To: Design and Landmarks Committee
From: Li Alligood, Assistant Planner and DLC Liaison
Date: May 16, 2012
Subject: Preparation for May 23, 2012, Meeting

Milwaukie Light Rail Station

The DLC will be holding a public meeting to review the design of the Milwaukie Light Rail Station (DR-12-04). Please review the materials thoroughly prior to the meeting, and contact staff with any questions. See Enclosure 4 for the staff report and attachments

Recommend that the Planning Commission approve application DR-12-04 with the recommended Findings and Conditions of Approval found in Attachments 1 and 2. This action would recommend approval of a design for the Portland Milwaukie Light Rail (PMLR) station in downtown Milwaukie.

Jump Span Lighting Refinements

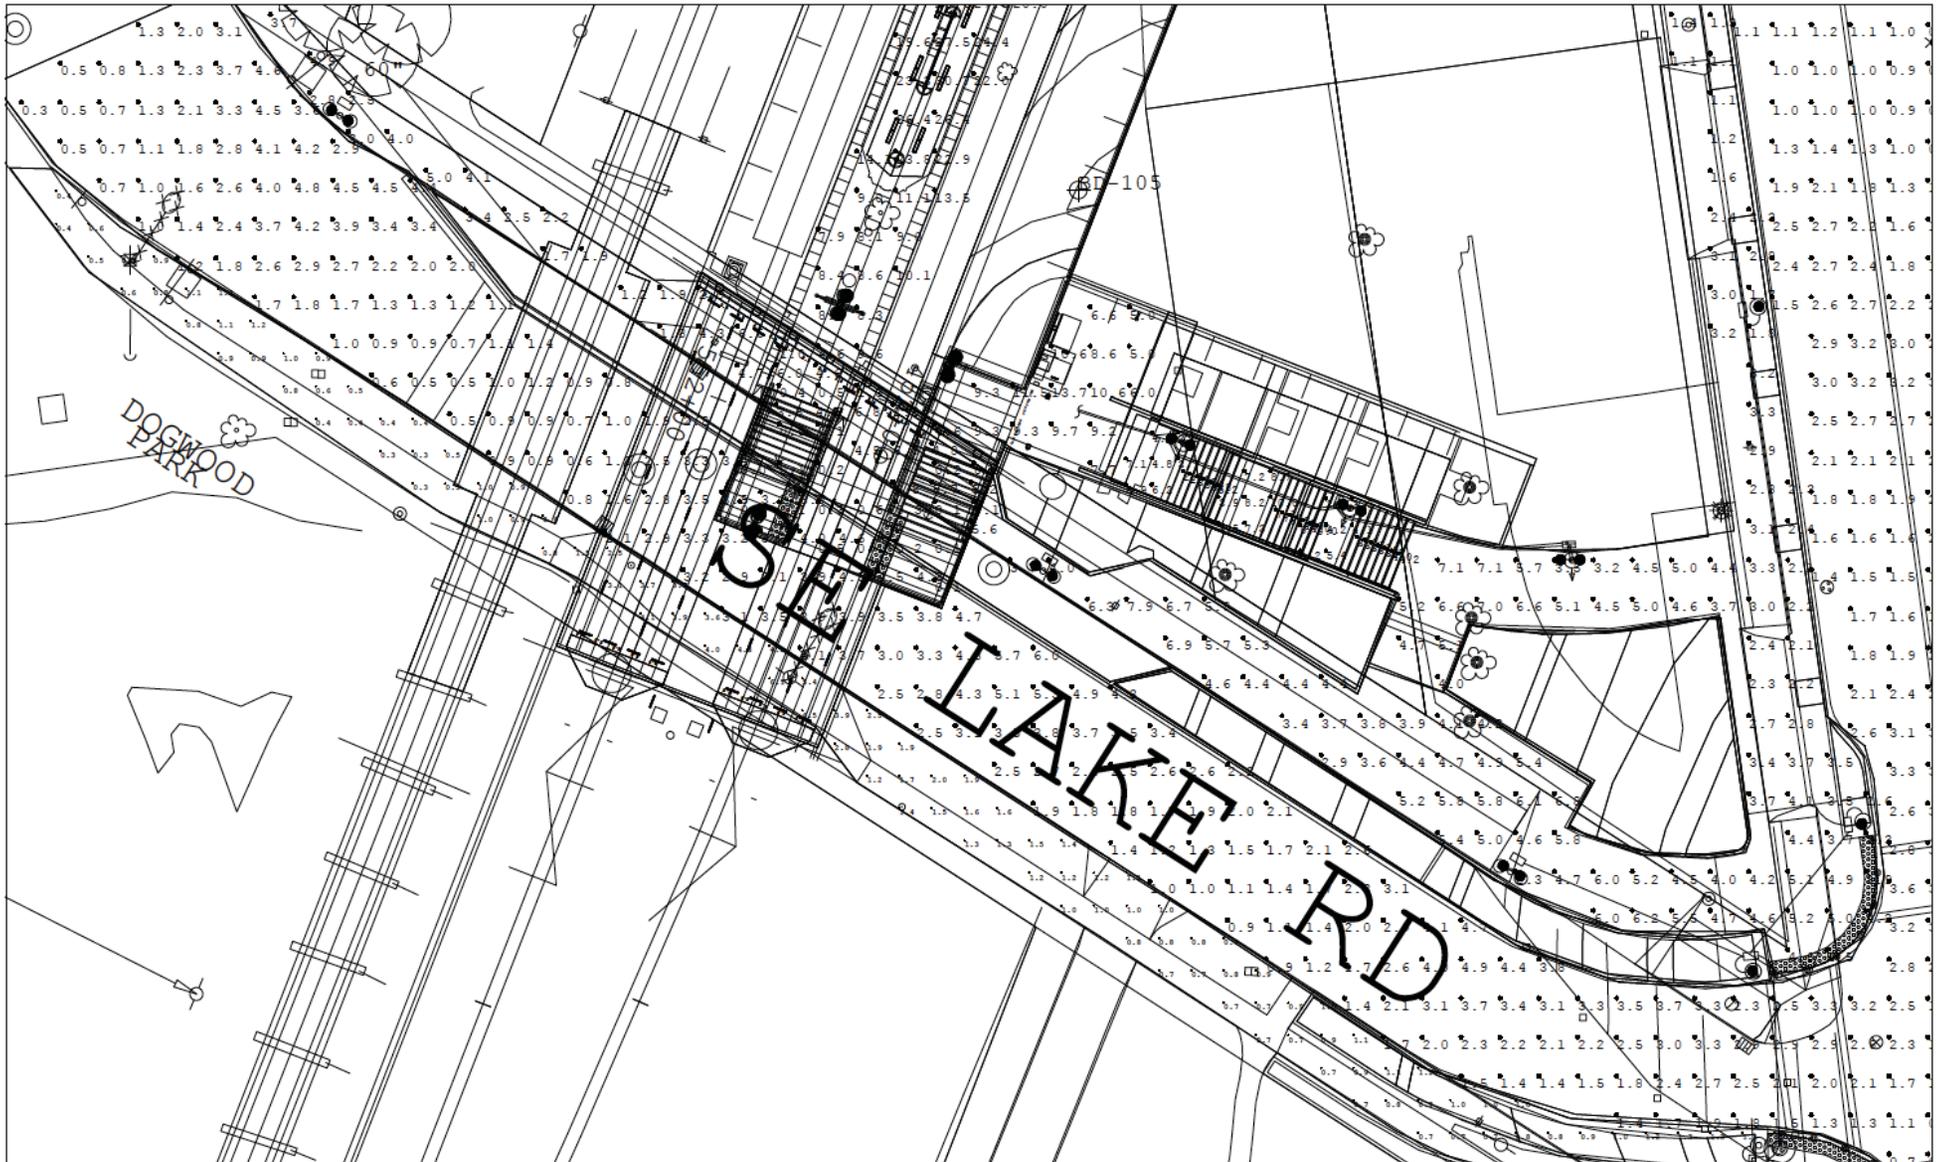
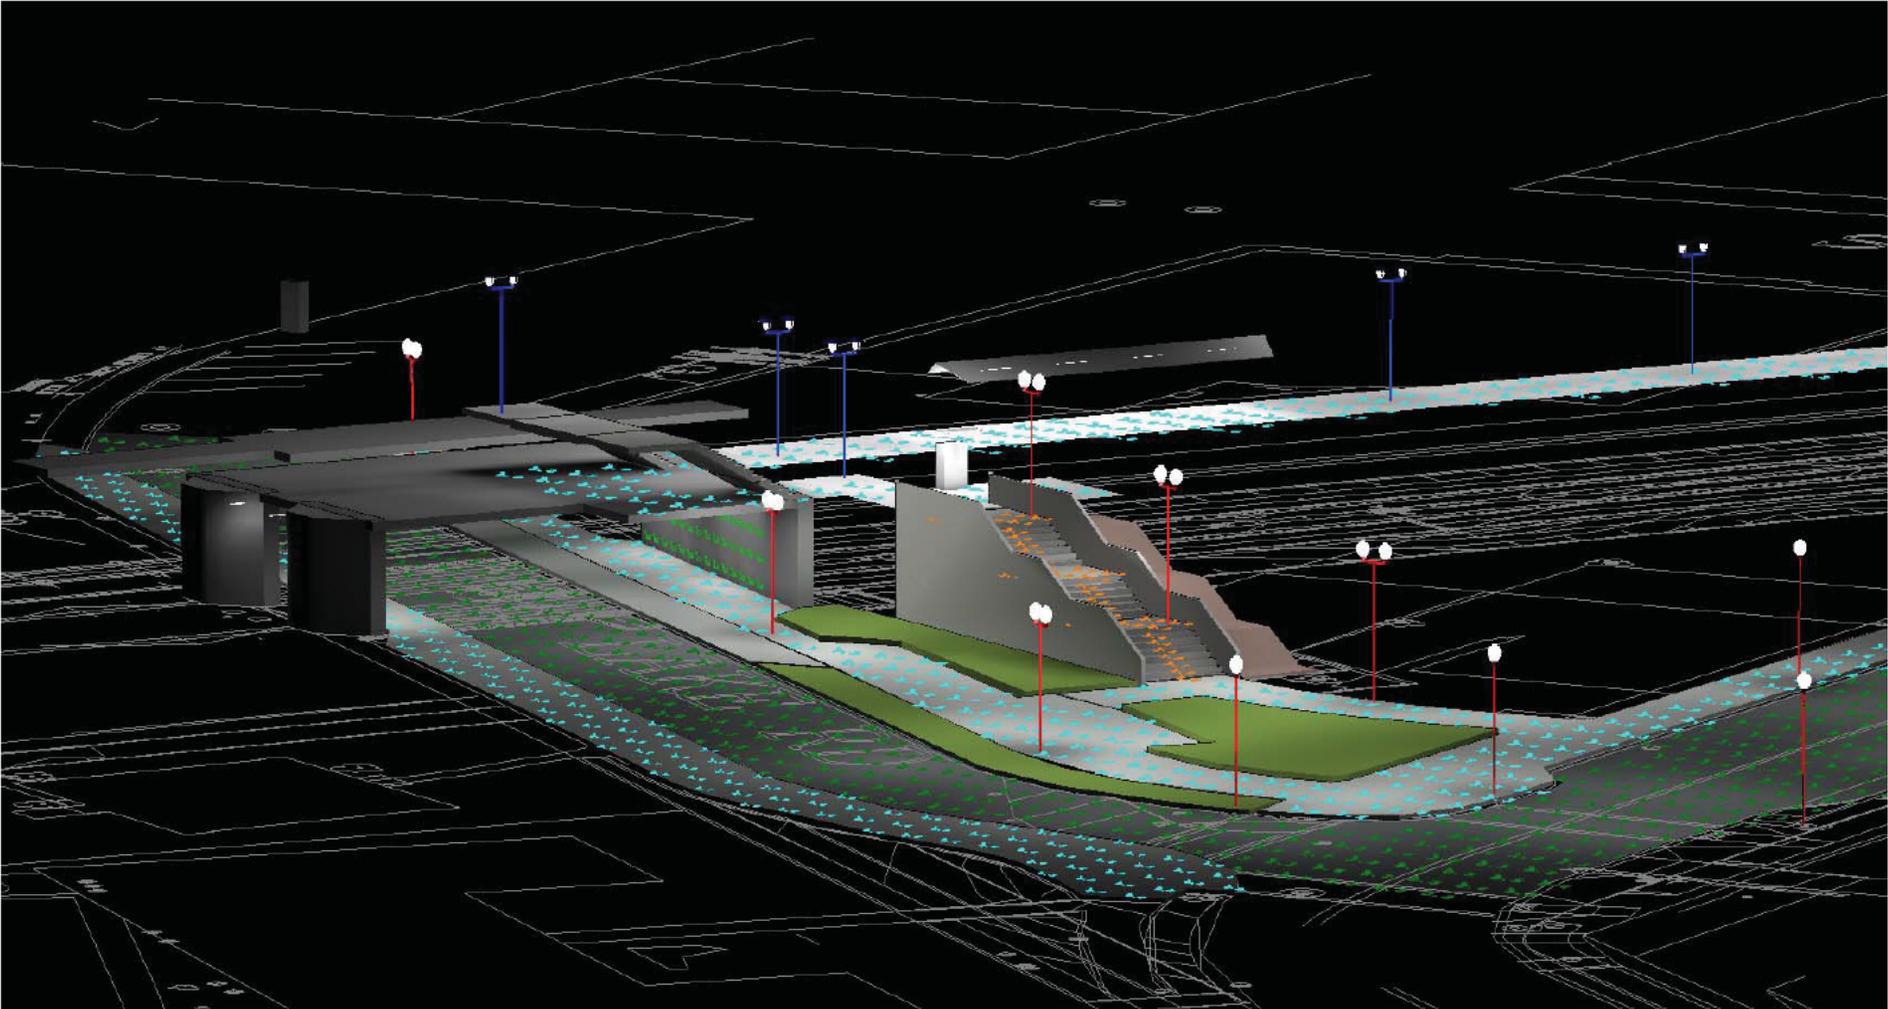
- Jump span over Lake Rd – During the land use review for the Kellogg Bridge (WG-11-01), the DLC requested additional information and different light fixture options for lighting underneath the Kellogg Bridge jump span. The Planning Commission

established a condition of approval requiring submittal of this information for consideration during the land use proceedings for the Milwaukie light rail station. The revised proposal includes linear LED luminaires recessed within the jump span slabs and placed at regular intervals. The applicant's photometric analysis indicates that the proposed fixtures will provide uniform lighting beneath the jump span, which minimizes glare and deep shadows. See Exhibits P 5A-B and P 6A-E of the application for details.

The DLC previously reviewed the proposed lighting treatment and generally approved of the design. However, a more detailed discussion of the proposal would be beneficial, as the applicant is seeking a recommendation that the Planning Director determine that this condition of approval is satisfied.

- The applicant's exhibits and photometric studies indicate that the fixtures would be linear LED luminaires; would light the area beneath the jump span to an average level of 3.05 foot candles in nighttime conditions; and would provide uniform lighting levels outside of and underneath the jump span, which minimizes glare and deep shadows. A well-lit area with minimal shadows and glare increases the pedestrian's sense of safety and comfort.
